ARCHITECTURAL REVIEW BOARD REGULAR MEETING AGENDA

Wednesday, March 18, 2026 | 7:30 PM

Agenda Item: APPLICATION FOR NEW CONSTRUCTION, ARB #26-001, located at 13100 and 13150 Worldgate Drive, Herndon, Virginia, located in the northeast corner of the intersection of Worldgate Drive and Centreville Road, to consider an application for the erection of a multi-family building and other minor site improvements at the property -- revised March 16, 2026

Agenda Item: APPLICATION FOR NEW CONSTRUCTION, ARB #26-002, to consider an application for the erection of stacked condominiums, townhouses, and other minor site improvements at the property located at 13100 and 13150 Worldgate Drive, Herndon, Virginia, located in the northeast corner of the intersection of Worldgate Drive and Centreville Road -- revised March 16, 2026

1. Second Floor Plan
Scale: 1/32" = 1'-0"

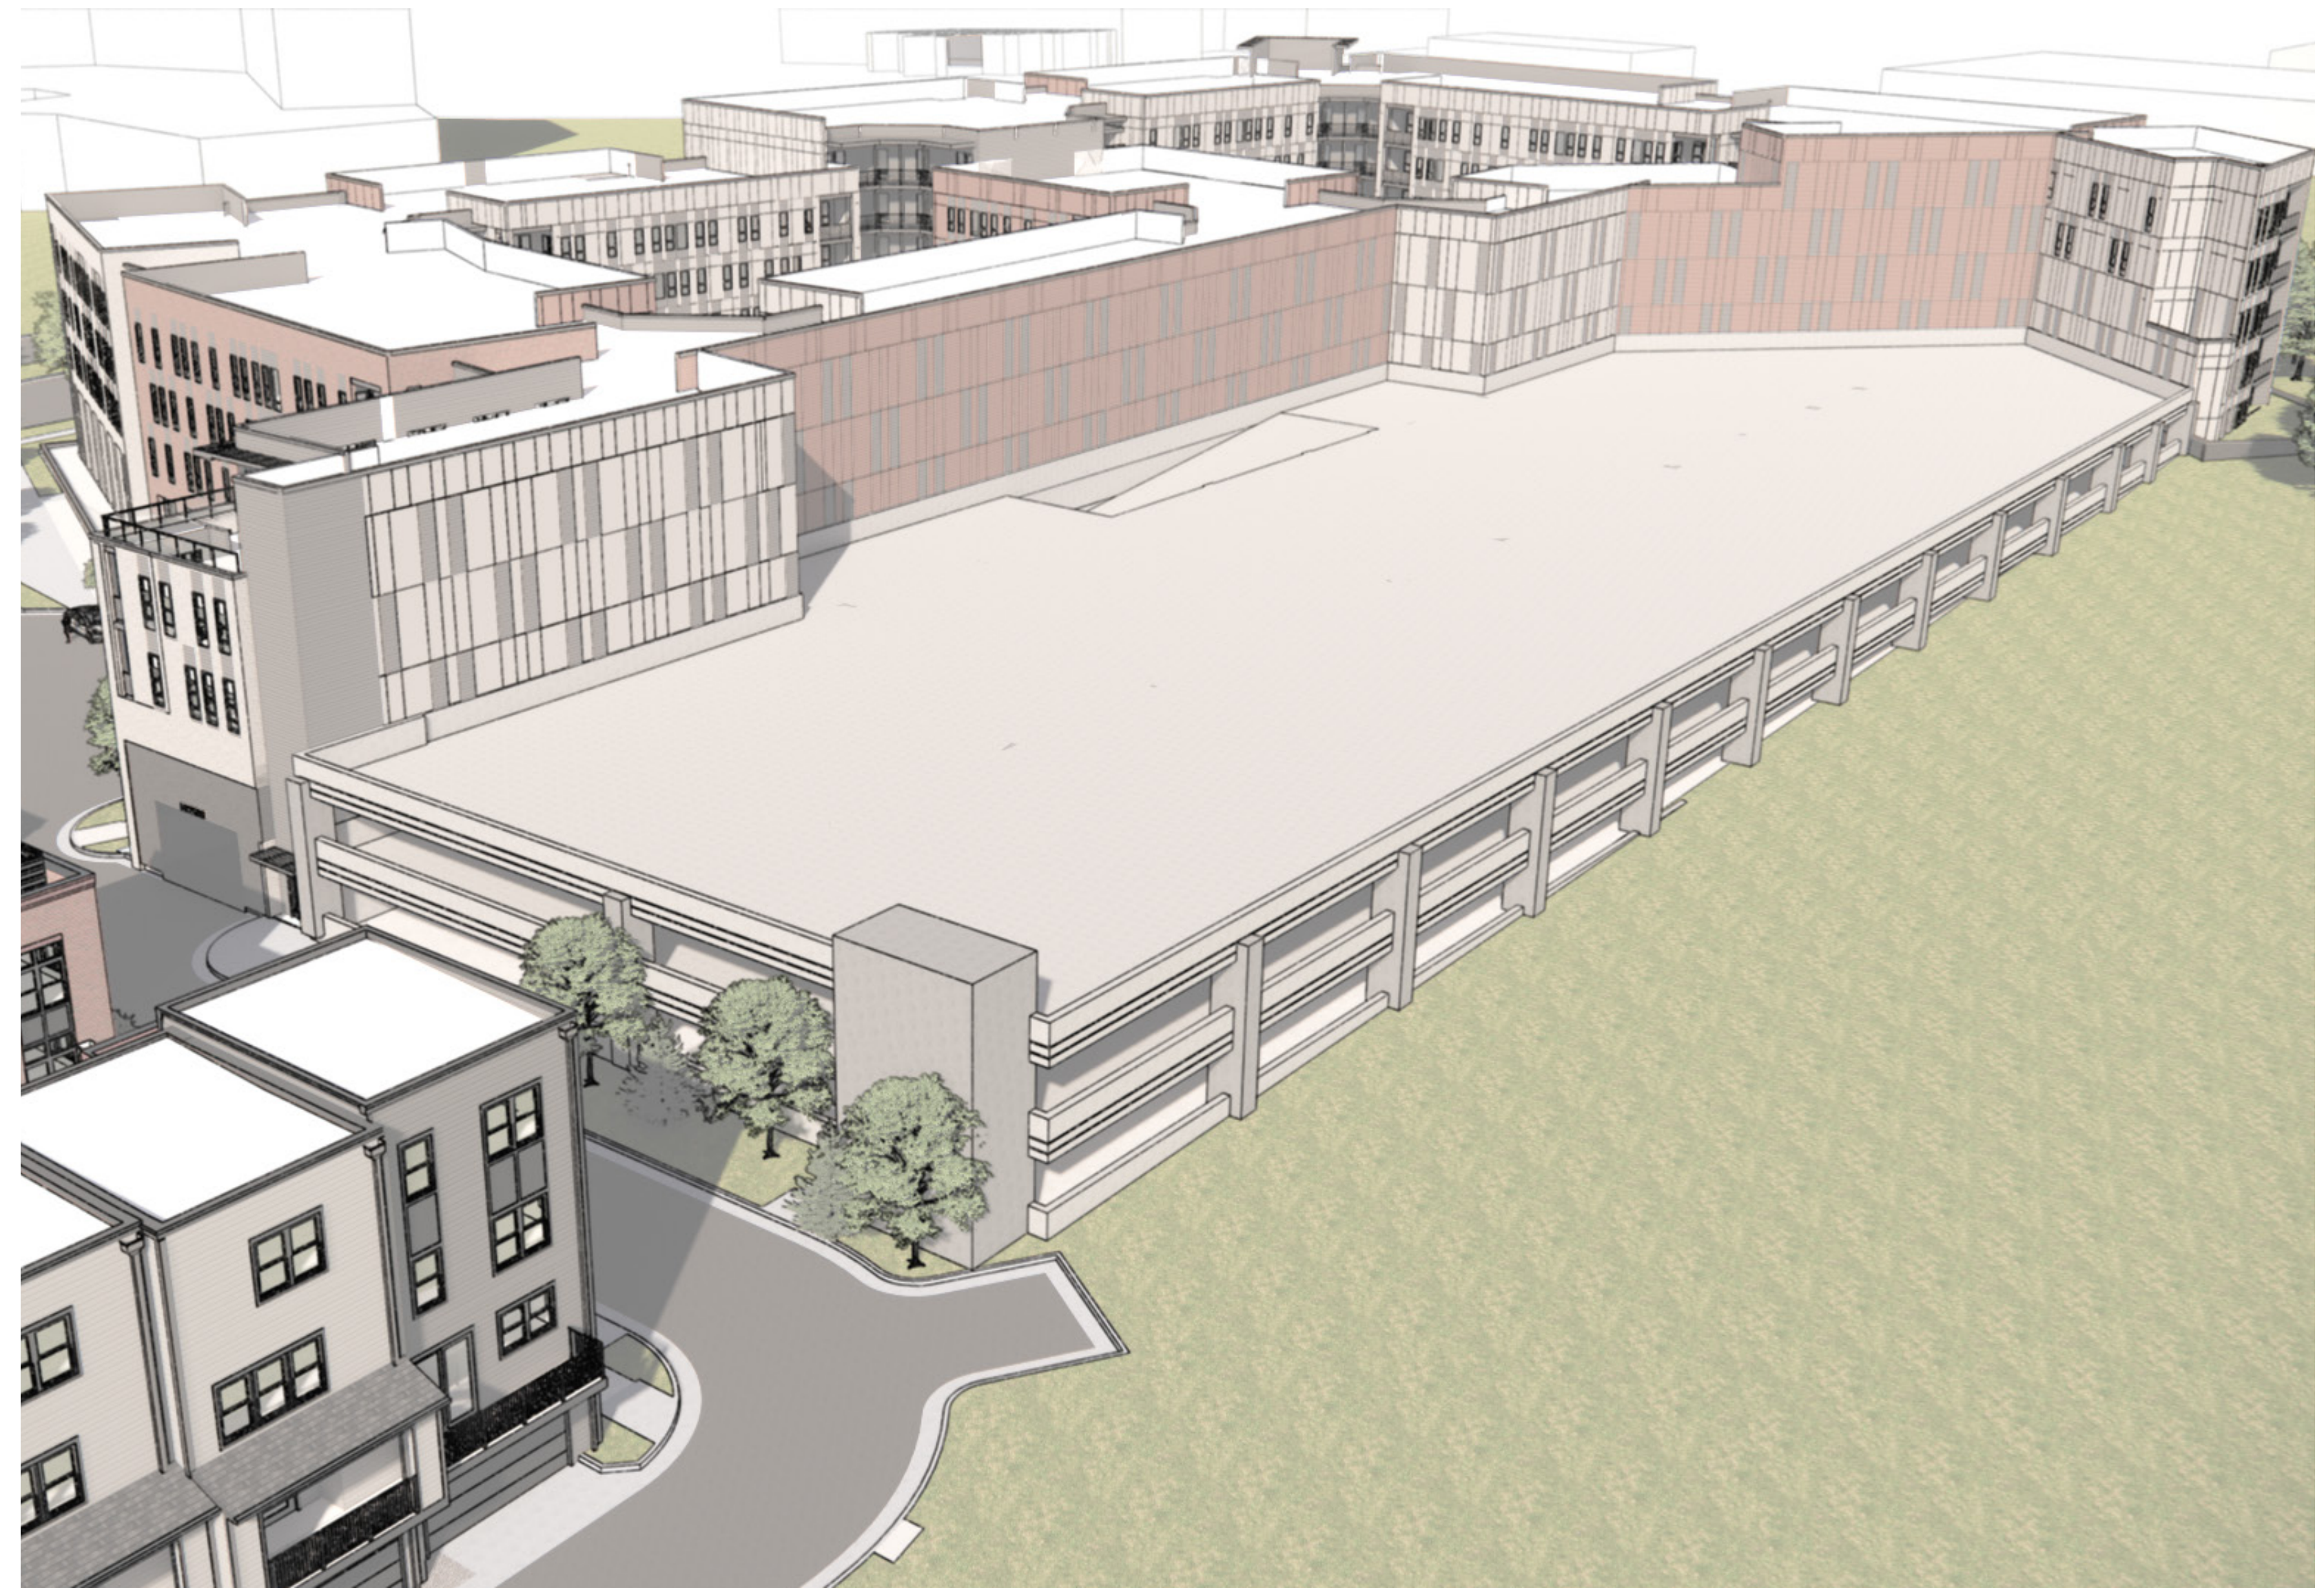
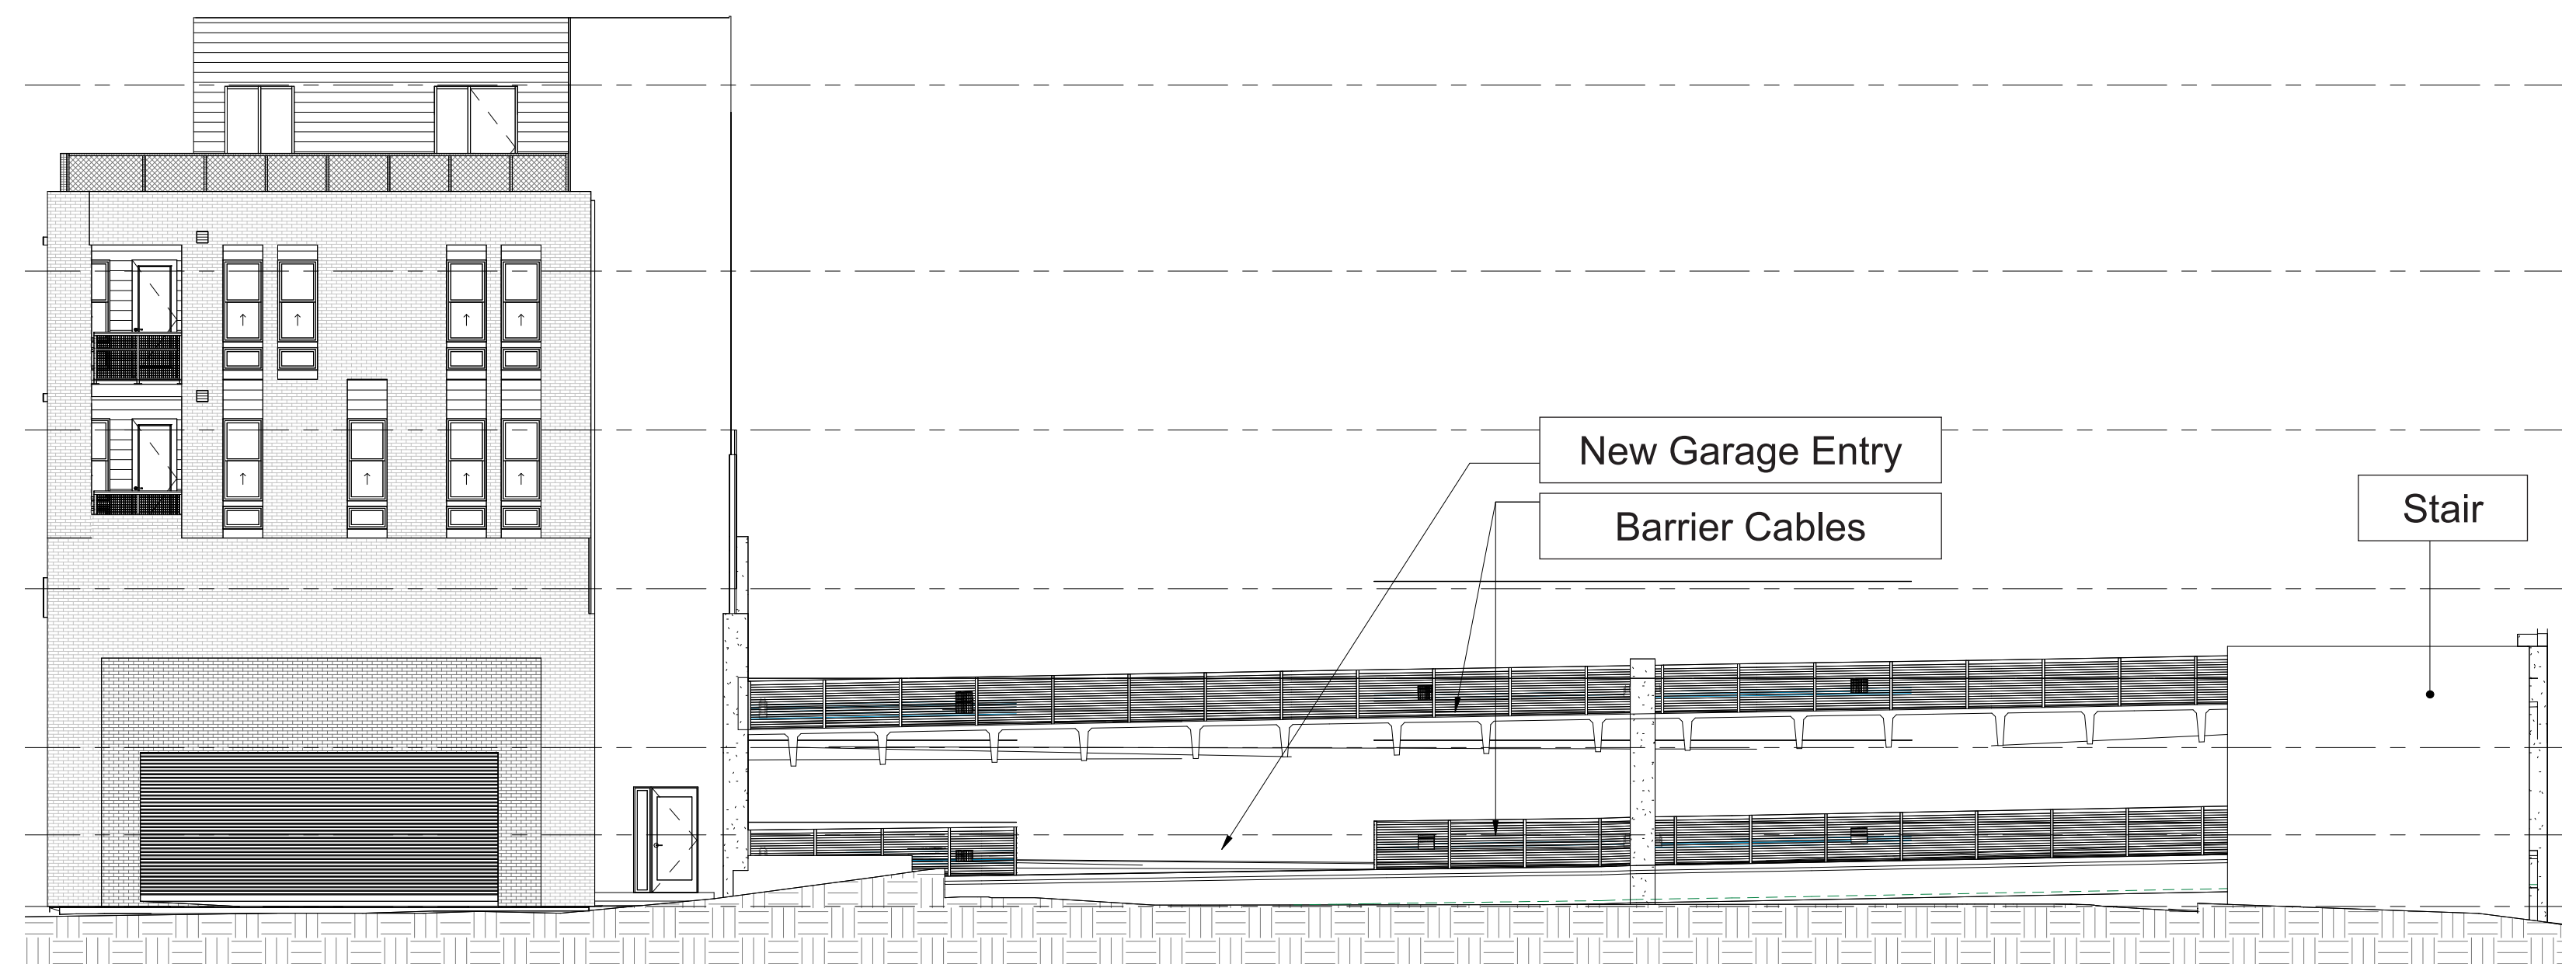
- The applicant submitted additional materials digitally to staff following the March 4 work session (these are consistent with the materials the applicant shared with the board during the work session):
 1. Second floor plan view and key showing how the existing garage interacts with the new multi-family component
 2. A perspective view of the façade articulation on Worldgate Drive to illustrate the façade composition
 3. A perspective view of the parking garage to show locations of stairs and porosity
 4. East Garage Elevation to show the new vehicle barrier cable system and the proximity of the garage and loading dock
 5. Precedent images demonstrating the articulation of fiber cement paneling in built projects
 6. Side-by-side comparison of the park spaces throughout the project to images from the GDP

Previous Condo Elevs.

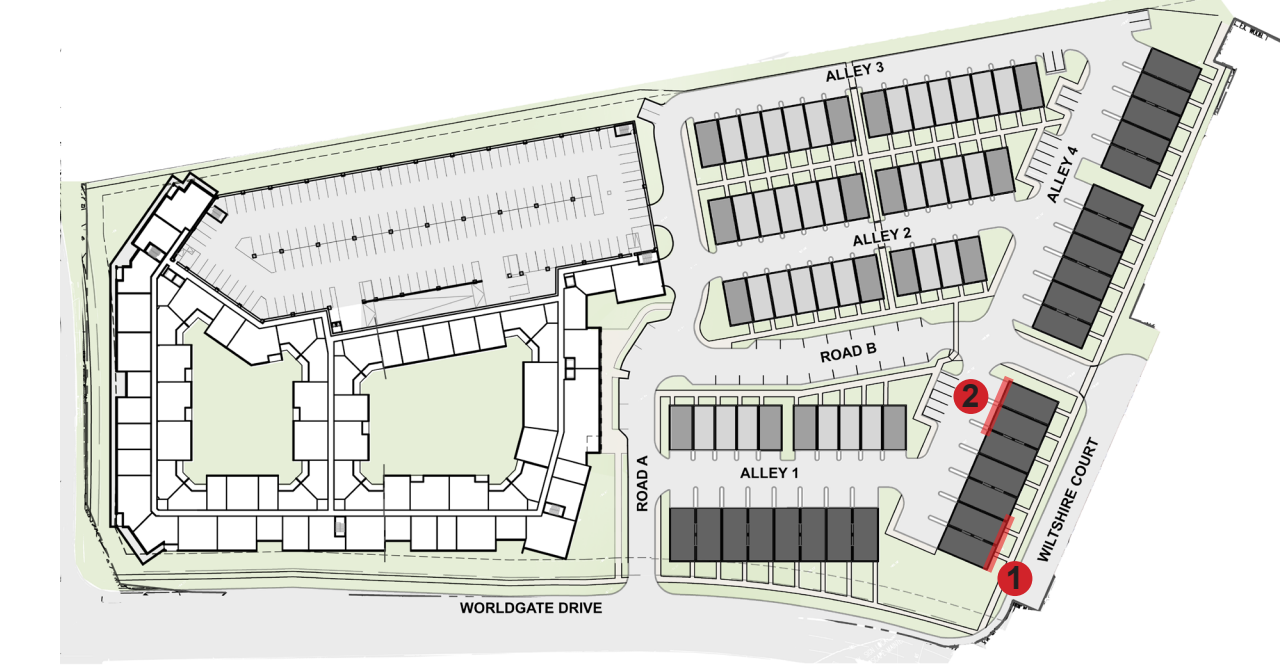
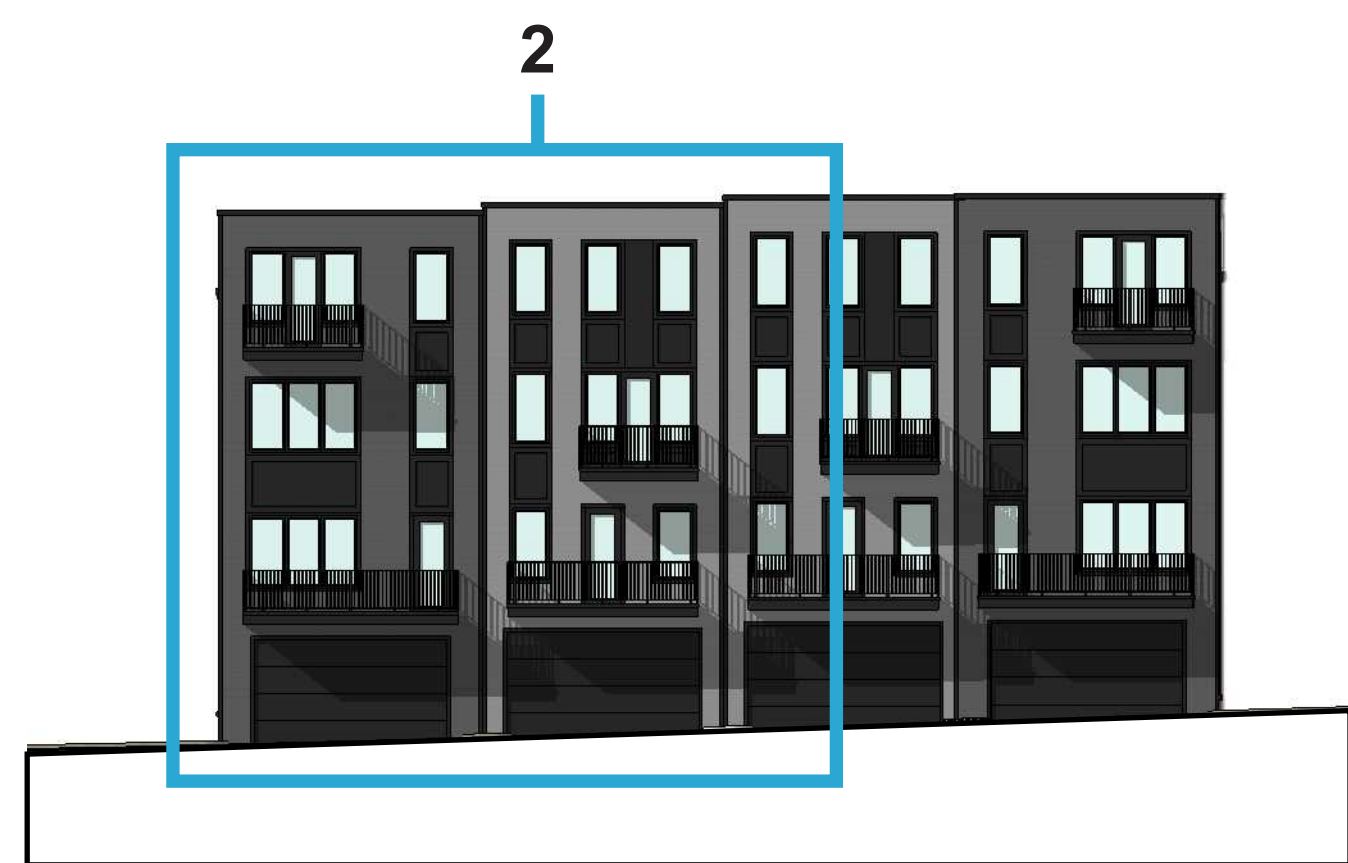
- The applicant provided a digital copy of additional materials that began to address some of the comments found in the March 4 staff report.
- The ARB asked the applicant to submit materials that compare the revised townhouse and stacked condominium elevations to the proffered elevations.
- The board requested to see the roof plan that demonstrates how the wall planes change for each building juxtaposed with the associated building elevation.
- The board also asked that the applicant provide the following datasheets for their review:
 - Exterior light fixtures
 - Conductor head/downspout details
 - Connection details for canopies

- The applicant submitted additional materials digitally to staff following the March 4 work session:
 - Annotated plan showing the footprint for all townhouse and stacked condo units
 - Materials showing the revised townhouse and stacked condominium elevations compared to the proffered elevations
 - Rendering depicting the stairs leading from the townhouses and stacked condos to the sidewalk
 - Material callouts for side elevations for both unit types
 - Canopy details
 - Exterior lighting specification sheet
 - Stair railing specification sheet
 - Lanai rendering
 - Garage specification sheet
 - Conductor head/downspout specification sheets

1. Perspective View - Condos Stoops
View from Wiltshire Ct.

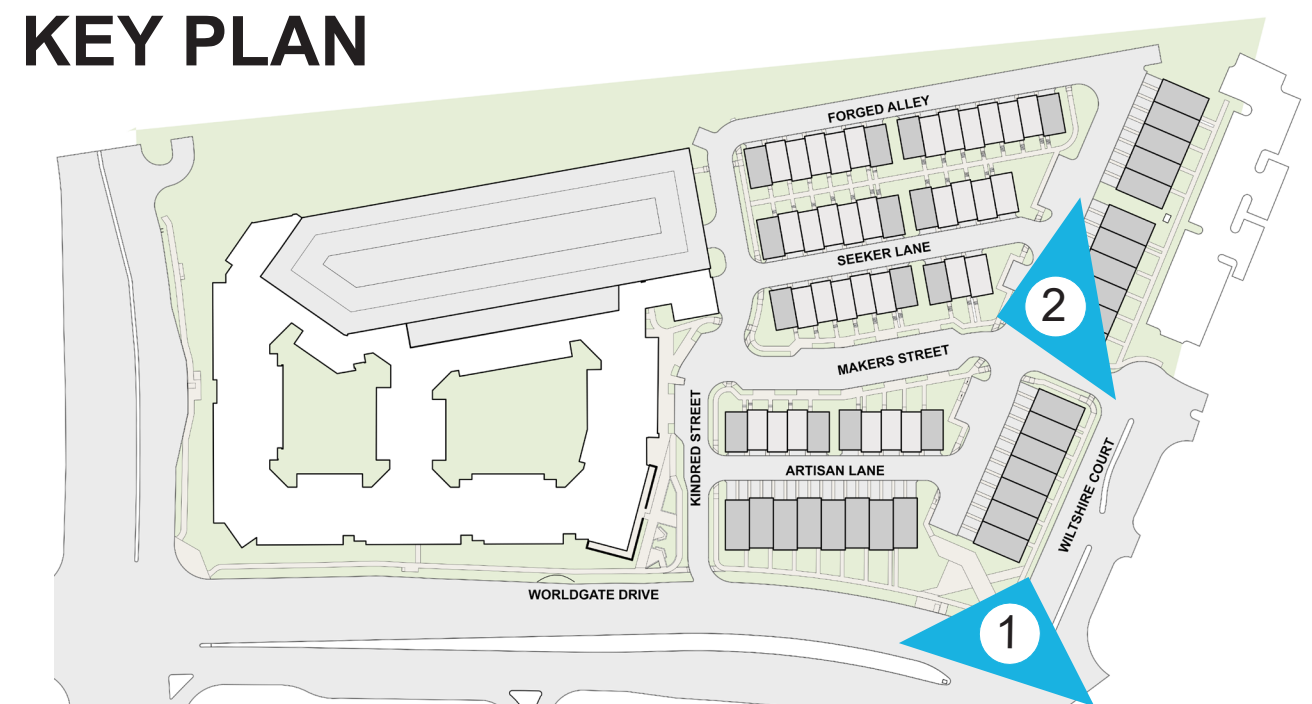
- The applicant let the board know that they created a rendering that depicts how stairs leading from the townhouses and stacked condos to the sidewalks will look from the street/pedestrian perspective.
